SIMTA Intermodal Terminal Facility- Stage 1

Response to Submissions -Noise and Vibration Addendum

Re: SIMTA Stage 1 - Review of Noise Impacts for Amended Rail Link Alignment

Figure 1 Amended Rail Alignment

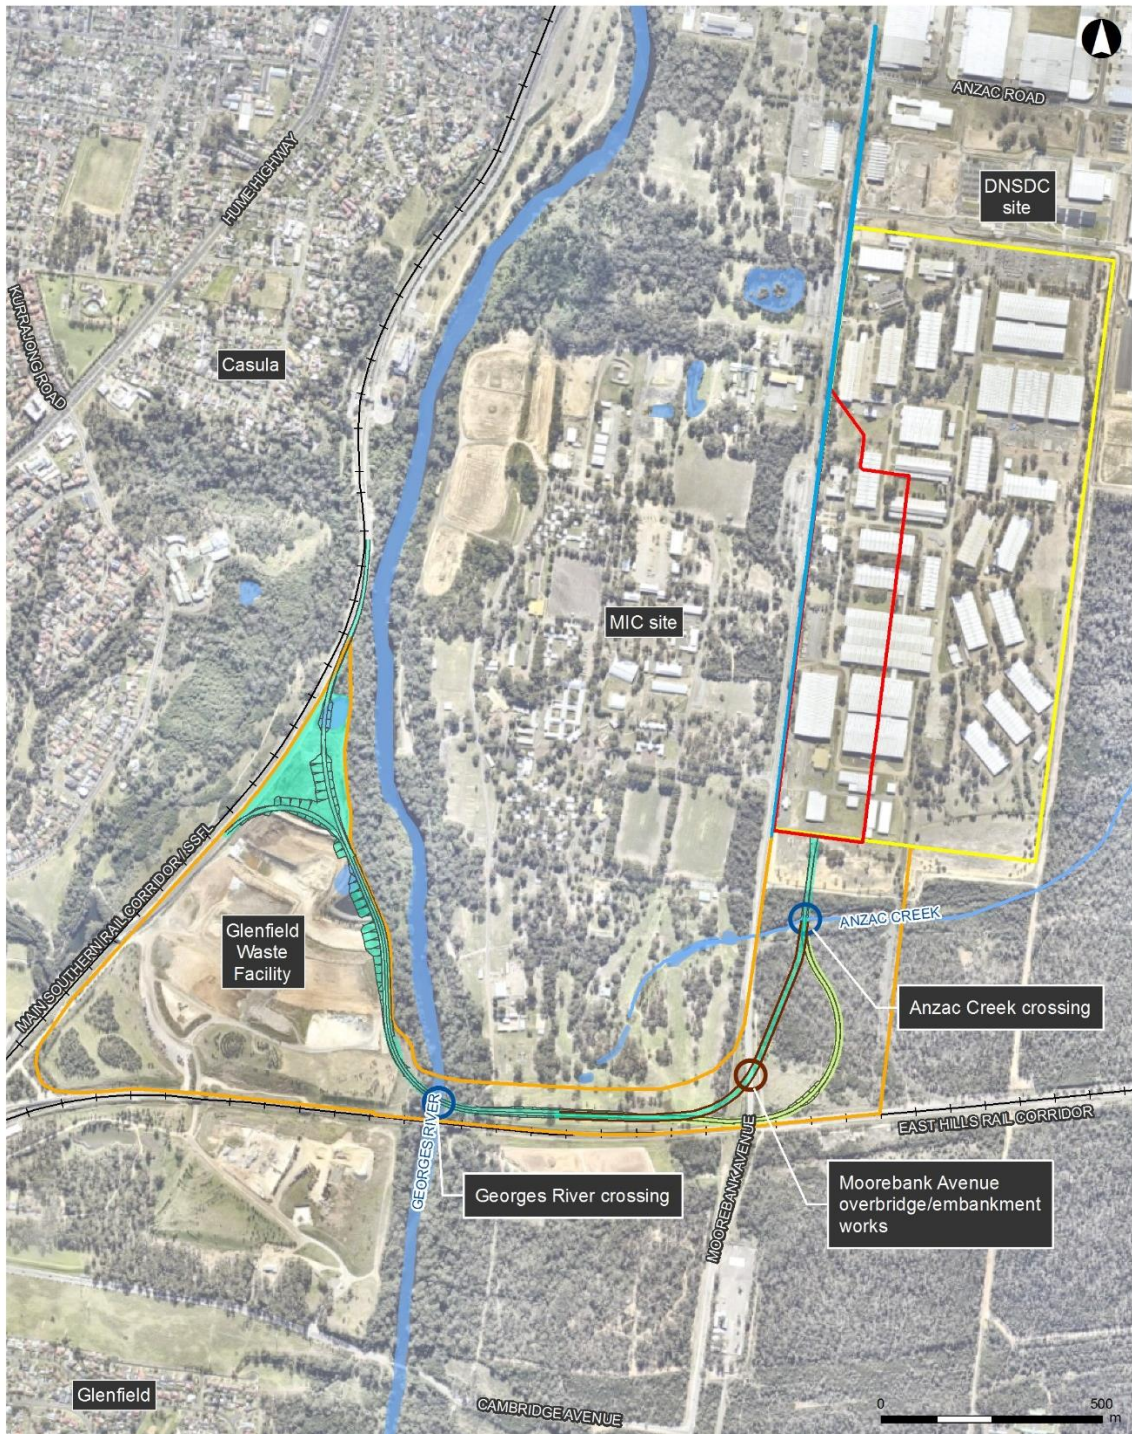
The Rail link is to be realigned within Commonwealth Land (including MIC Site, Moorebank Avenue and the Southern Boot Land) to respond to submissions (received during the exhibition of the EIS (28 May 2015 and 26 June 2015)) and also to reduce the overall environmental impacts of the Proposal (refer to Figure 1).

This realignment would alter the Rail link alignment to the south of the Anzac Creek Crossing, at the intersection with Moorebank Avenue and also on the MIC site (to the immediate west of Moorebank Avenue). The rail alignment would retain the 20 metre width of the Rail Link Corridor within environmentally sensitive areas, as per the Concept Plan Approval (MP 10_0193) and the EIS.

This alteration in the rail alignment would result in Moorebank Avenue being intersected by the Rail link further north of that previously identified within the EIS. An alteration would be undertaken to the

existing Moorebank Avenue road embankment to create an overbridge to accommodate the realigned Rail link.
